## Questions and Answers No. 2

## **SWM Expanded Polystyrene Densifier** RFB Specification No. **ES24-0213N**

33762624 SHEET NO. E-6 SHEET 23 OF 23

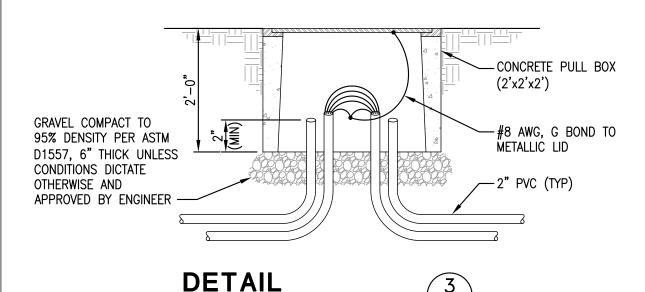
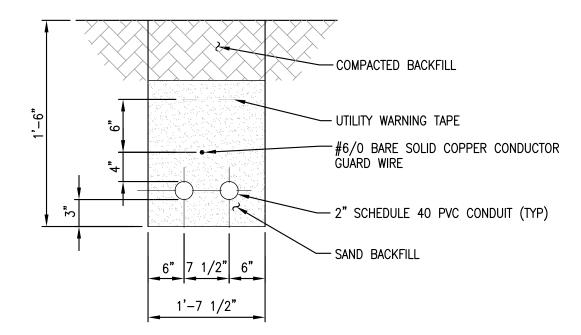
1. Question: Where is the "WASH BUILDING" is located at, highlighted on the Electrical line drawing in relation to the Densifier building?

Answer: See the attached drawing for layout of the site electrical.
